Project: Proposed Agricultural Storage Shed on land adjacent Cheshire Cheese House, Penley, LL13 0LU.

Drawing: Block Plan.

| SA24946/202 | B    | 1:750 | A3    | Date: July 2017 |

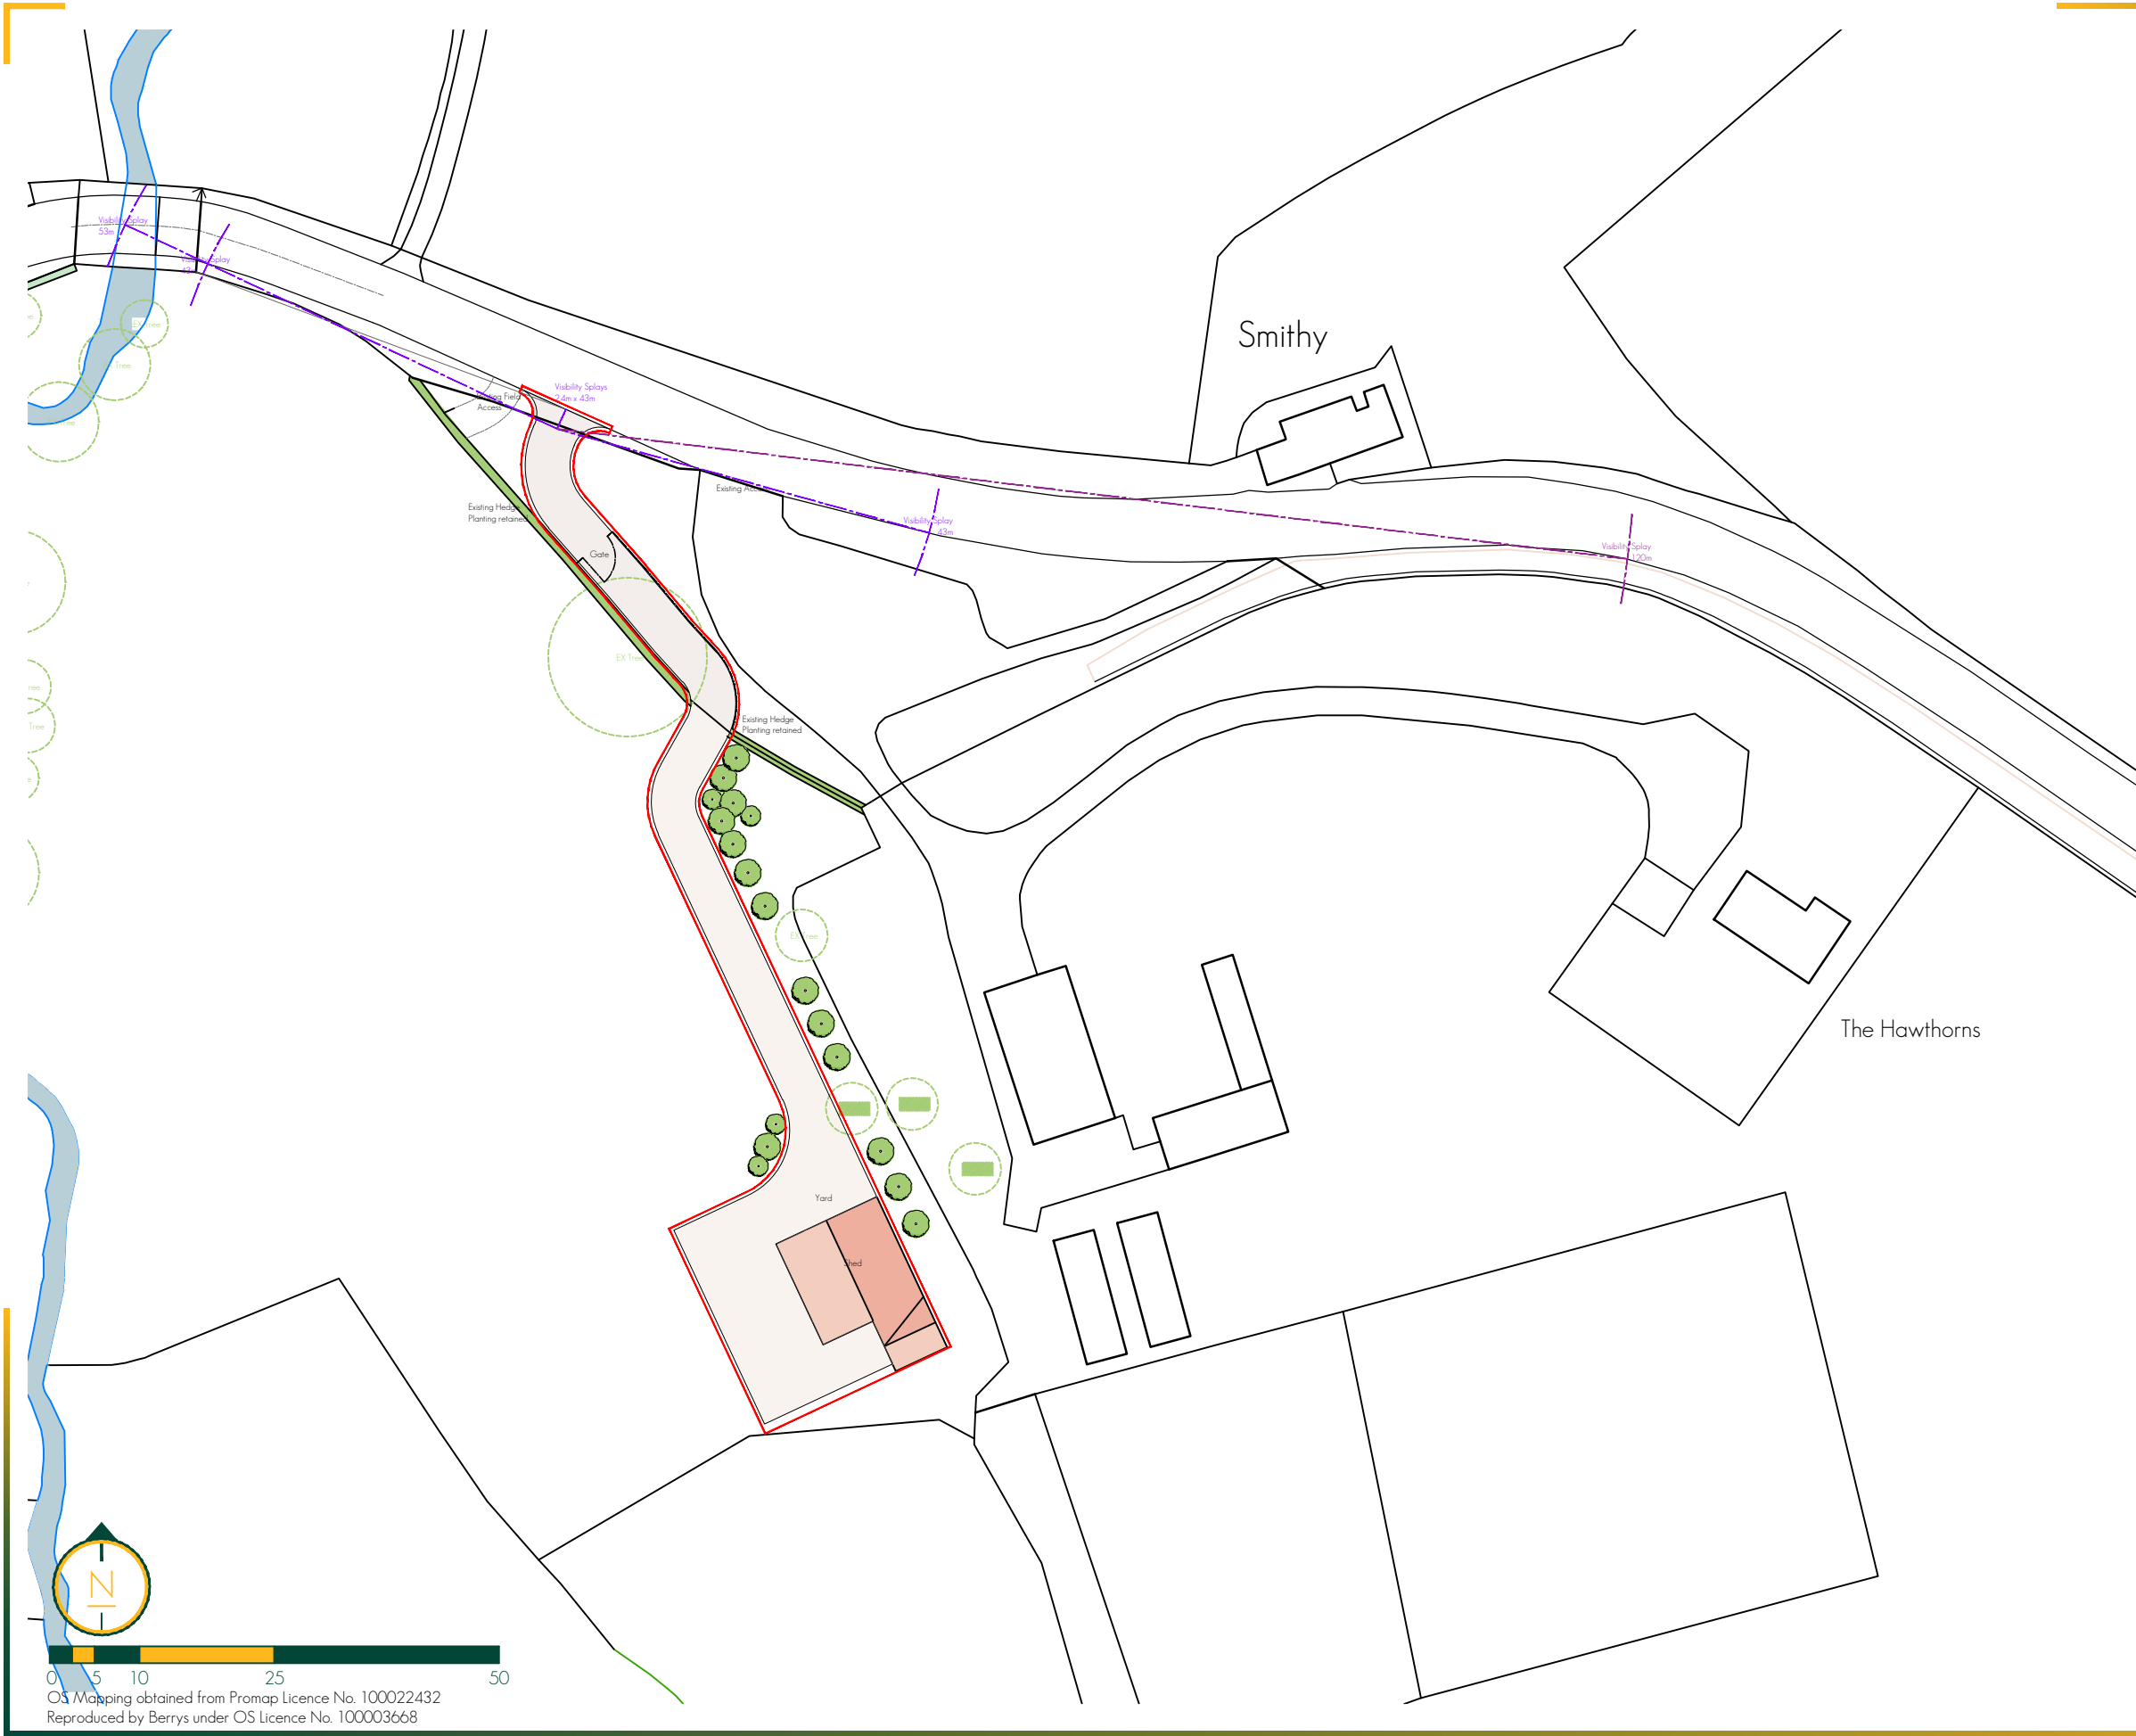
- Amendments:
- A Access and visibility splays amended as per officer request. 04/10/17
  - B Scale amended. 30/10/17

Access to utilise existing access point, using 5m width of across the existing 7.5m long dropped kerb. Access road and entrance to site to be 5.0m for its entirety.

In line with TAN 18 guidelines a 30mph visibility splay of 2.4 x 43m has been provided. Although the road is deemed a 40mph road, due to the nature of the road to the West of the access, it is considered that cars would not be travelling at maximum speed through the preceeding road and would in fact be more likely to be driving between 20-30mph. It can also be considered that maximum visibility can easily be achieved to the East of the access.

Whilst the measurement to the East shows the visibility splay to the nearside of the carriageway, the measurement to the West shows both the distance to the nearside and the centreline of the carriageway. As per Manual for Streets 2, 'if approaching vehicles from the left are unlikely to be carrying out an overtaking manoeuvre, then the sight line in this direction can be adjusted to the centreline of the road'. It can be regarded that no one would be overtaking due ot the preceeding nature of the road to the West. This Westerly Visibility Splay therefore shows that we are able to exceed the deemed required visibility splay.
